<b>Docket Number:</b>	19-SPPE-01
<b>Project Title:</b>	Laurelwood Data Center (MECP I Santa Clara I, LLC)
<b>TN #:</b>	229557
<b>Document Title:</b>	Report of Conversation - Silicon Valley Power Responses to Questions from Staff
<b>Description:</b>	Silicon Valley Power (SVP) Responses to Questions from Staff Conversation between Lisa Worrall of the CEC and Kevin Kolnowski, SVP
<b>Filer:</b>	Marichka Haws
<b>Organization:</b>	California Energy Commission
<b>Submitter Role:</b>	Commission Staff
<b>Submission Date:</b>	8/27/2019 3:14:23 PM
<b>Docketed Date:</b>	8/27/2019

**PROJECT TITLE:** Laurelwood Data Center **Docket:** 19-SPPE-01

**SUBJECT:** Silicon Valley Power (SVP) Responses to Questions from Staff

EDGECORE  
 LAUREL SITE  
 SINGLE LINE DIAGRAM  
 SIMPLIFIED

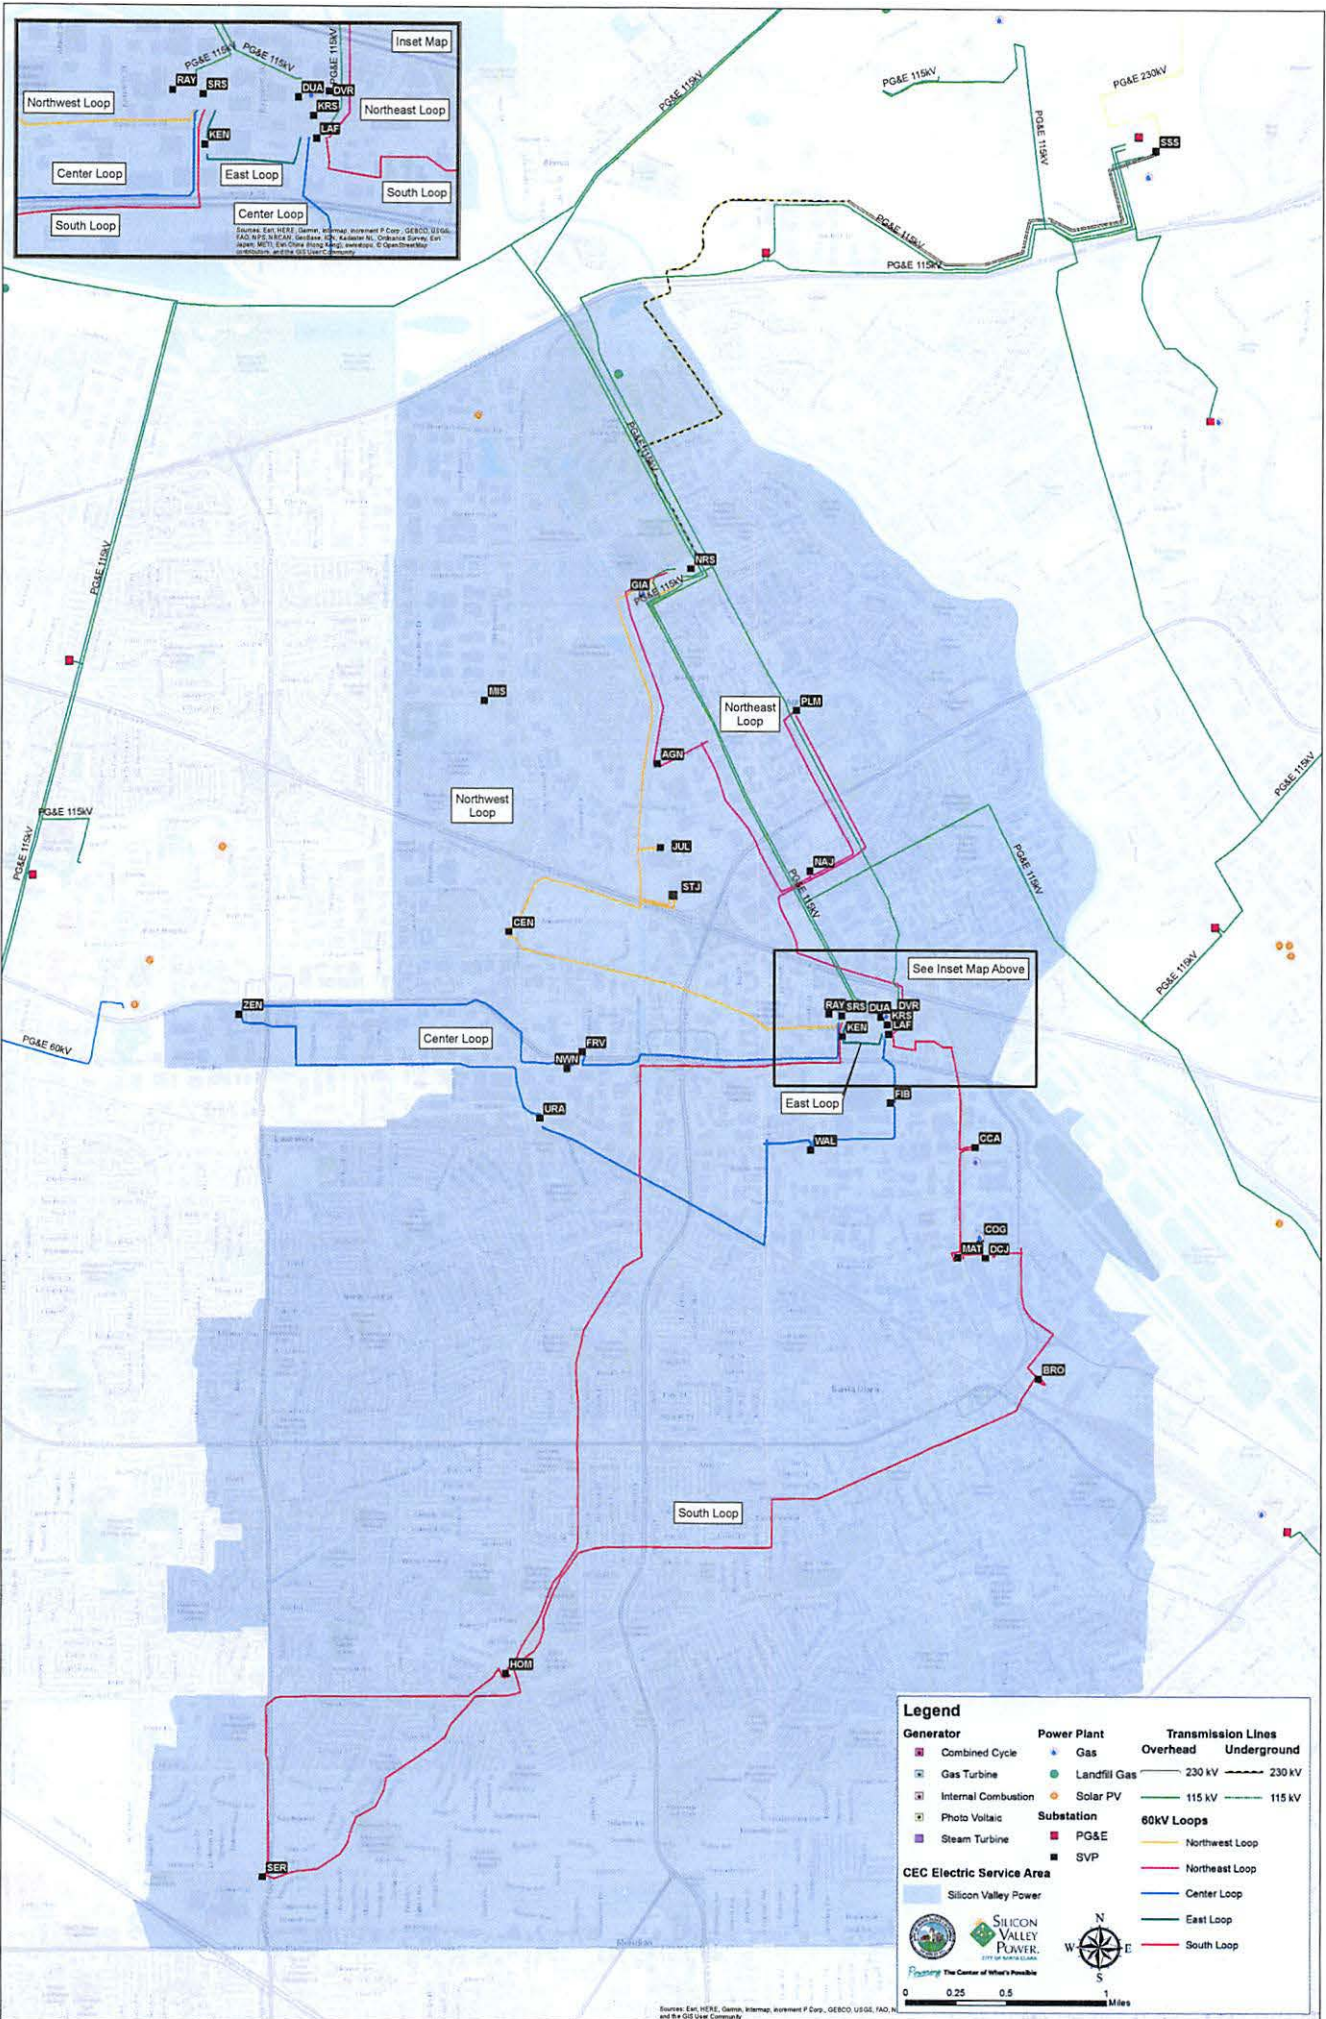
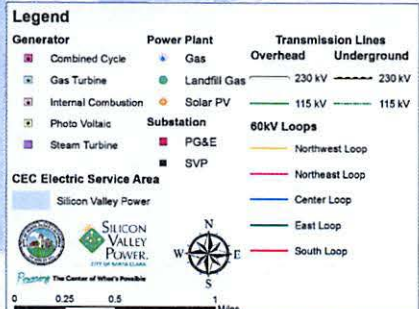
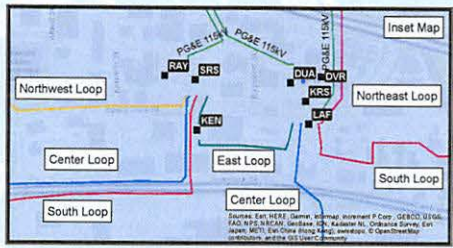
1. Please provide for the 60 kV loop on the SVP system that will serve the MECP1 data center:
  - a. A physical description

- b. The interconnection points to SVP service

- c. The breakers and isolation devices and use protocols

San Tomas Junction is a three-50MVA (60kV:12.47kV) transformer bank substation on SVP's 60kV Northwest Loop. It is located between SVP's two 60kV Substations, Central (CEN) and Juliette (JUL). Each Transformer has a proposed rating of 30/40/50 MVA. The final buildout of San Tomas Junction will have a capability of 99 MVA, with 150 MVA of installed capacity which increases its reliability. The customer's Single Line Diagram (SLD) "LAUREL SITE SINGLE LINE DIAGRAM SIMPLIFIED" is attached.

The Interconnection points to SVP will be the three high-side transformer gang switches. SVP's nomenclature will be drafted as GS36, GS26, and GS16.

There are four 60kV Breakers at San Tomas Junction shown on customer SLD, CB1, CB2, CB3 and CB4 which will enable various isolation schemes to insure a transformer bank can be isolated while the other two transformers remain in service. The system is designed such that one of the transformers can be taken out of service for repairs or maintenance while the other two can fully support customer load.
